# Dundrum Central

## Architectural Response to An Bord Pleanála Opinion

Dundrum Central SHD  
Proposed SHD on Lands at the Central Mental Hospital,  
Dundrum Road, Dundrum, Dublin 14  
Issued for SHD Planning Application  
March 2022

Project No: P19-233  
Document Title: Arch. Response to ABP Opinion  
Document Number: DCD-RAU-XX-SW\_XX-RP-A-9004

Figure 13 - Cross section cutting through site at Blocks 08, 07 and 03 facing north.

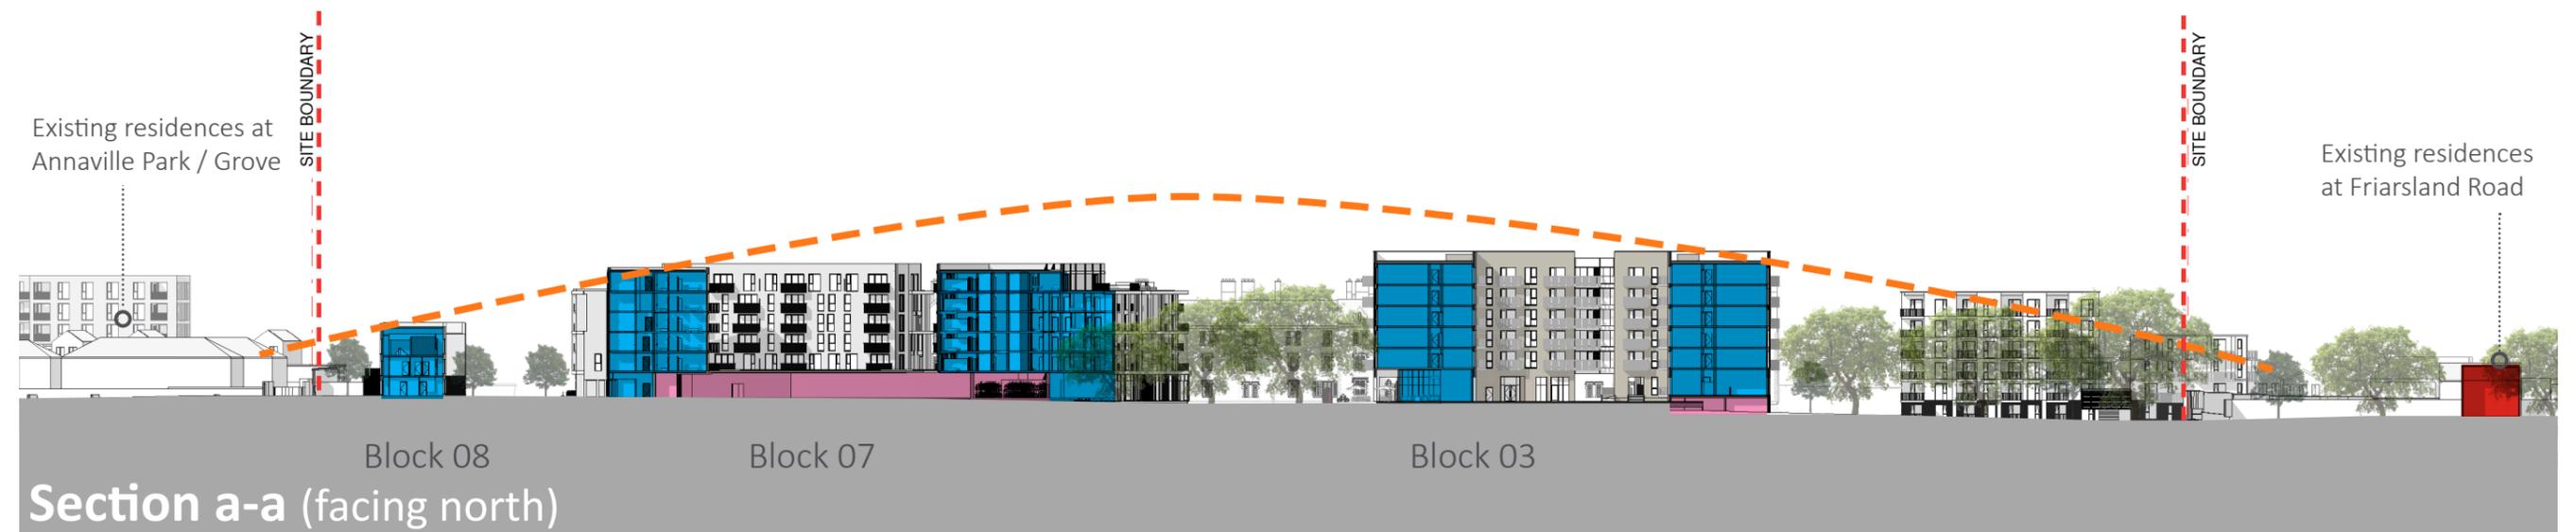
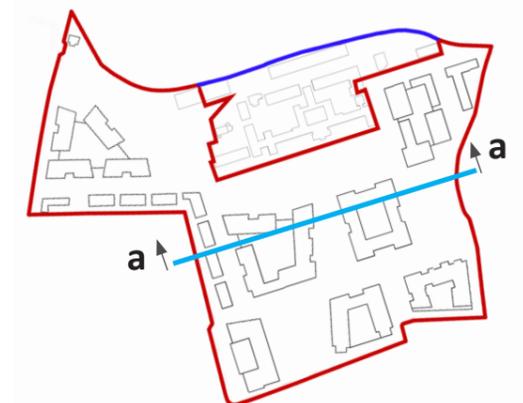
Building heights have been stepped down at locations where the site is directly adjacent to neighbouring buildings. Further information on the relationship between the proposed development and the neighbouring properties is available in the Townscape and Visual Impact Analysis prepared by Macroworks and in the Sunlight and Daylight analysis prepared by GIA, among other documents.

Figure 21 - By removing sections of the boundary wall at Rosemount Green, community and landscape features on-site will be made accessible to existing housing to the south.

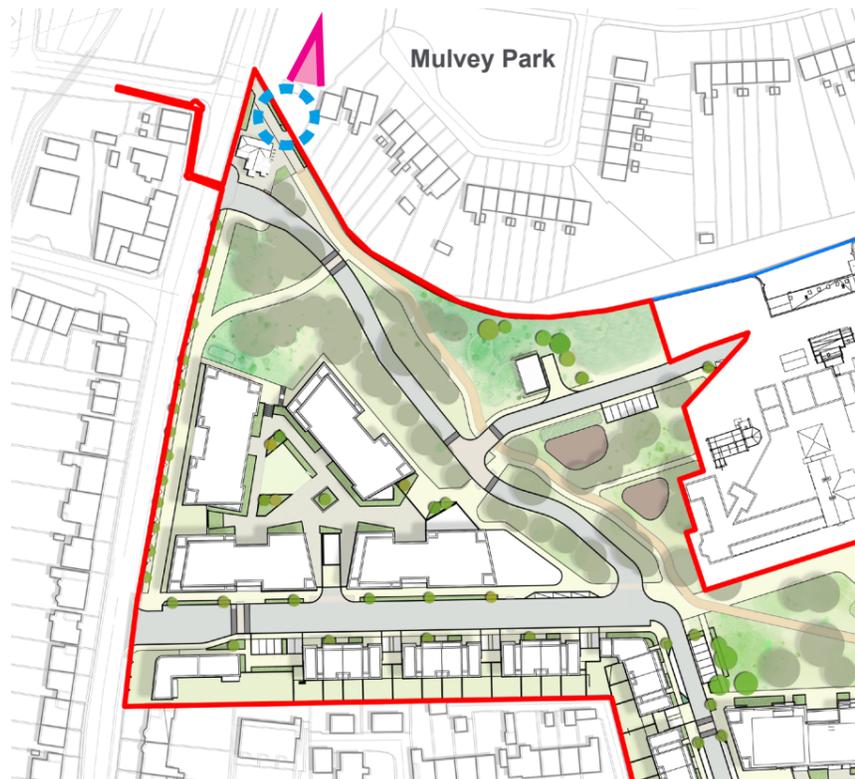
*(b) A contextual layout plan which indicates the layout of adjoining developments, photomontages and cross sections at appropriate levels, including details of how the proposed development interfaces with contiguous uses/lands and adjoining roads (within Anneville, Larchfield, Friarsland, Mulvey Park, Rosemount Green and Dundrum Road).”*

Proposed view from Rosemount Green showing extension of green space.

**Note:** No alterations proposed to Rosemount Green.

Figure 33 - View from Block 03 balcony looking east towards Friarsland Road with Walled Garden in foreground.

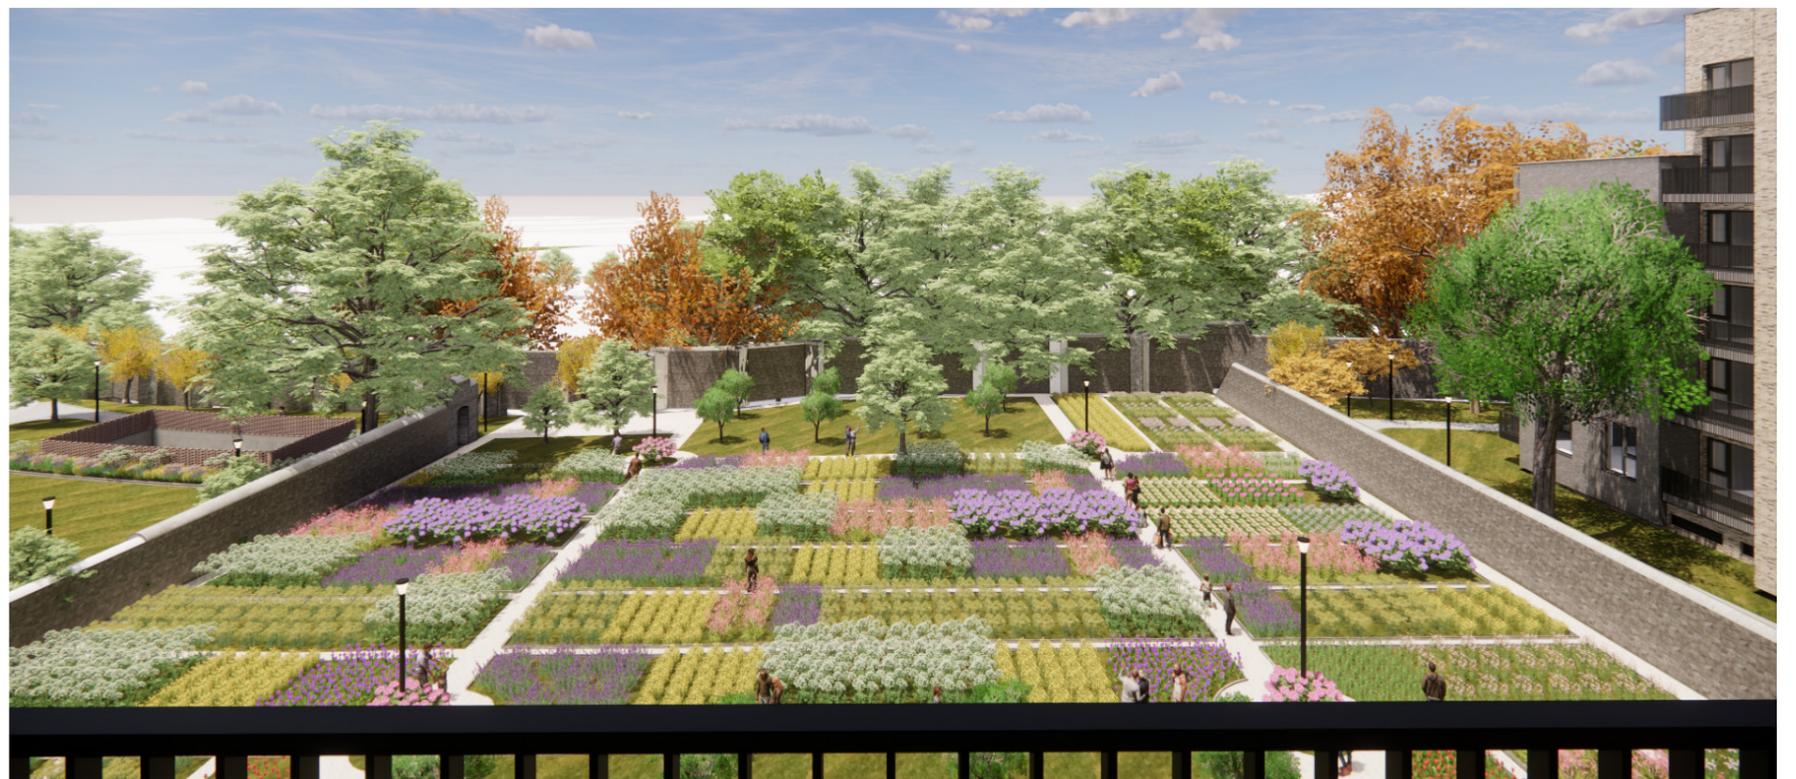
“Further consideration and / or justification of the documents as they relate to residential amenity, having particular regard to the potential for overlooking, overshadowing and overbearing impacts on existing adjoining residential properties and proposed residential units within the scheme. The response should include a detailed Sunlight, Daylight and Shadow Assessment of inter alia units proposed, communal open spaces, public open spaces and adjoining lands and properties.

- Building heights reduced across the development.
- Block 02 height reduced adjacent to Main Hospital Building.
- Unit typologies adjusted at courtyard of Block 03 to increase size of courtyard and to improve the sunlight hours at the Block 03 communal amenity space.
- Elements of building footprint removed at Block 08 to reduce impact to existing apartment building at Annville.
- Building height reduced at western edge of Block 06 adjacent to existing residential development at Annville Grove.
- Building height reduced at Block 10 adjacent to Dundrum Road.
